IEEE P802.3at Task Force Power Via MDI Enhancements

Midspan 100BT ALT A TX output signal template Addressing Draft D3.2 comment #76

Yair Darshan / Microsemi Corporation,
November, 2008

Proposed Strategy

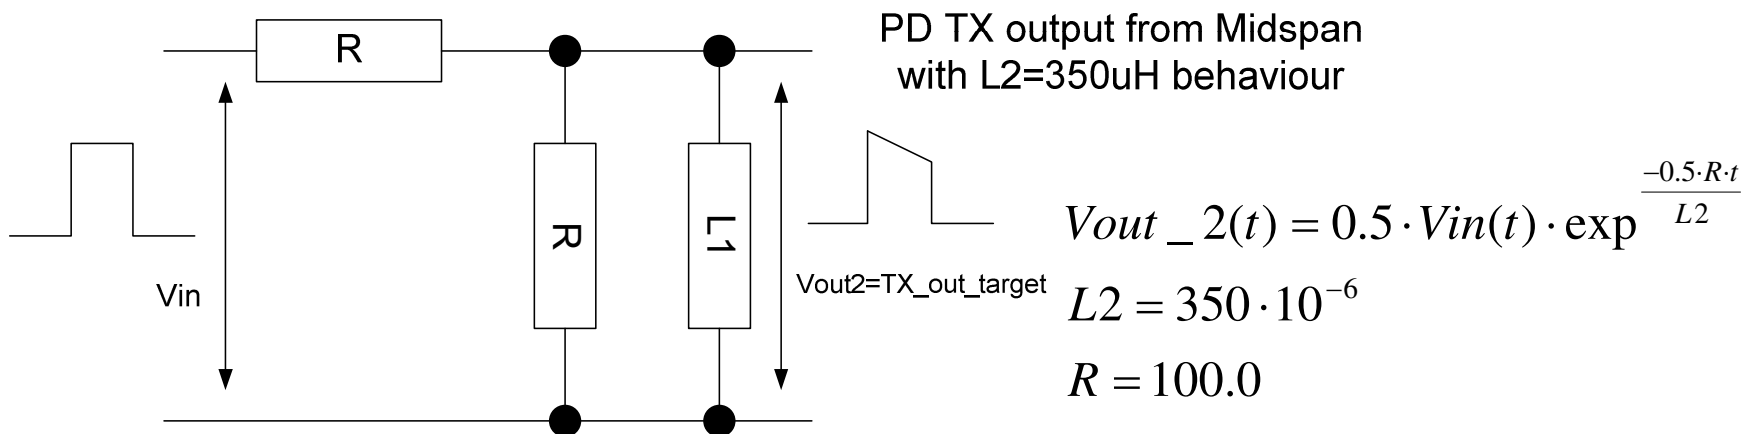
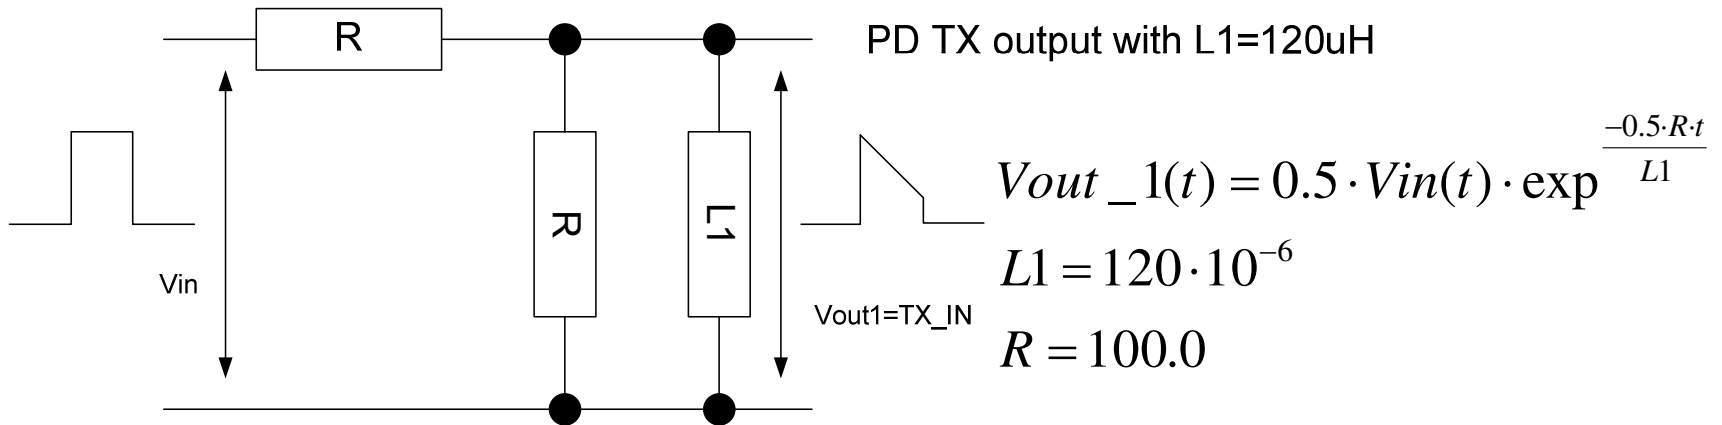
- Midspan gets a signal from PD TX with a droop generated by 120uH equivalent OCL.
- Midspan output a signal with a droop equivalent to 350uH OCL.
- This approach defines new Midspan ALT A Transfer Function which will replace Eq 33-18 when this alternative will be used
 - We can not use the droop method based on transmitting data packets since Midspan has no access to data. It is easier for Midspan to use frequency domain template i.e. Transfer Function approach.

Simulation Model

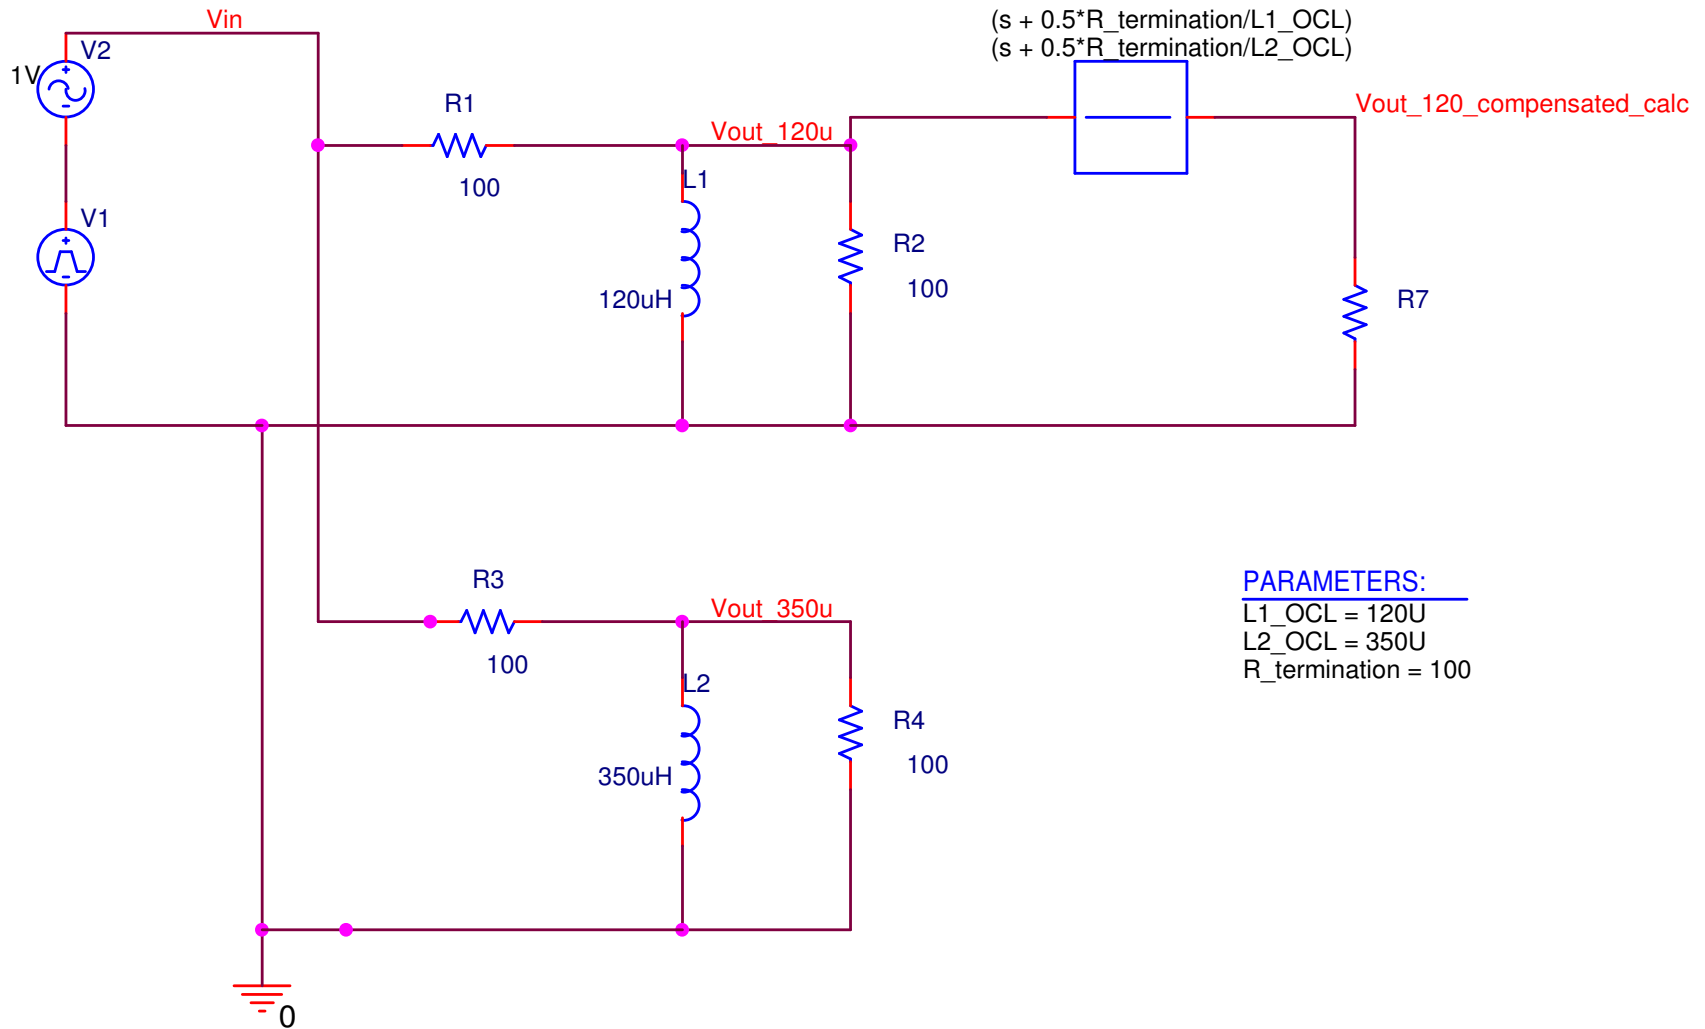
The 120uH TX signal source was connected to a Eq 33-18a.

Simulation Results

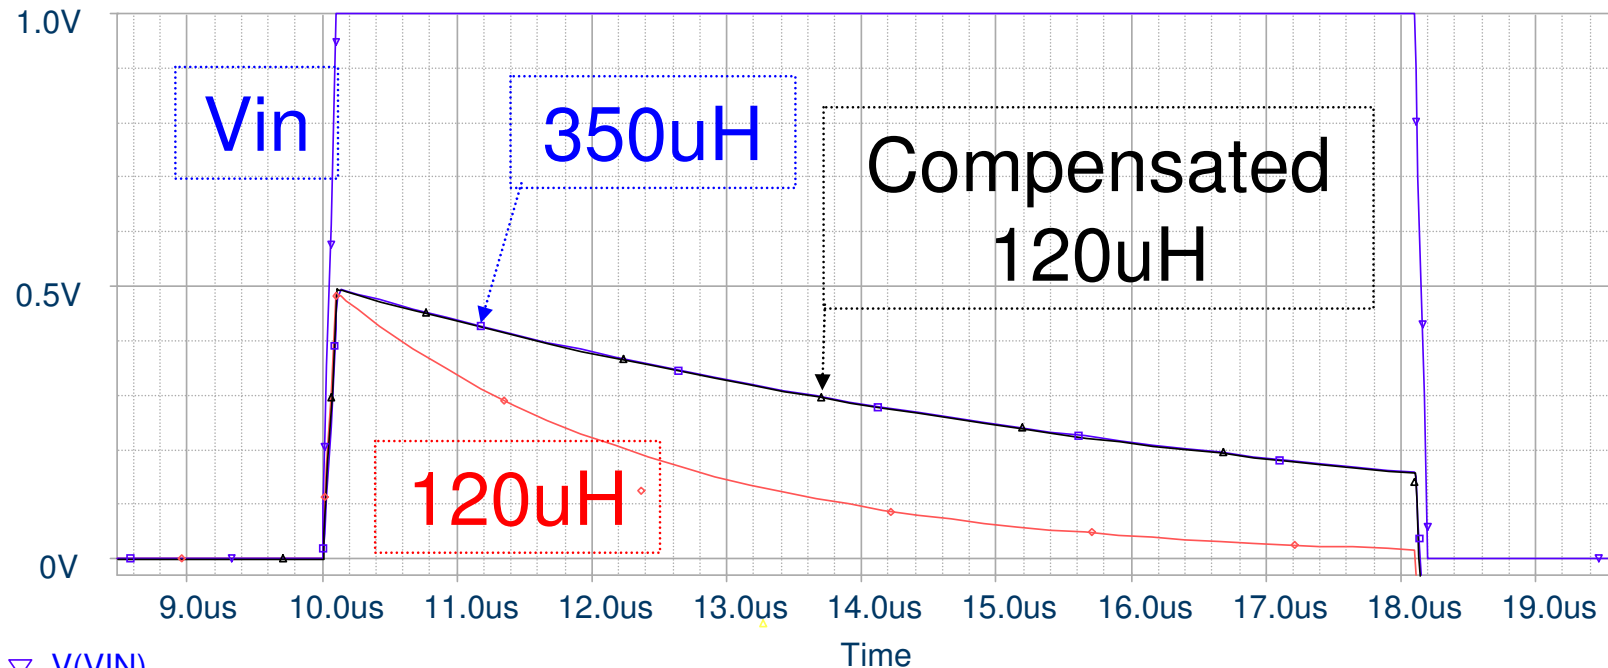
- ▽ V(VIN)
- ◇ V(VOUT_120U)
- V(VOUT_350U)
- △ V(VOUT_120_COMPENSATED)

■ Applying the TF to the 120uH signal source results with 350uH signal behavior

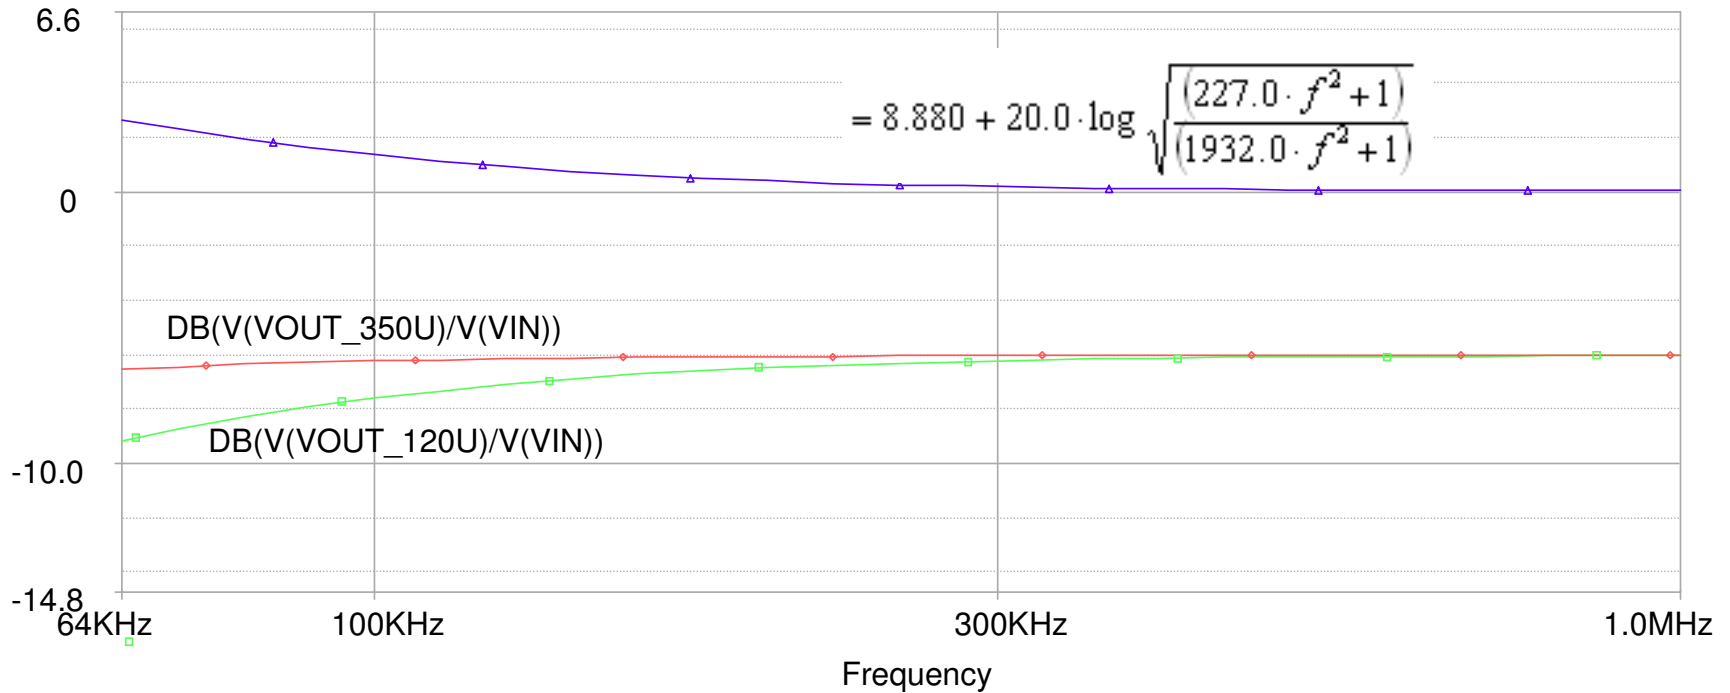
In the frequency domain we got the exact same results as it should be..

$$\triangle \text{ DB(V(VOUT_350U)/V(VIN)) - (DB(V(VOUT_120U)/V(VIN))) } = 8.880 + 20.0 \cdot \log \sqrt{\frac{(227.0 \cdot f^2 + 1)}{(1932.0 \cdot f^2 + 1)}}$$
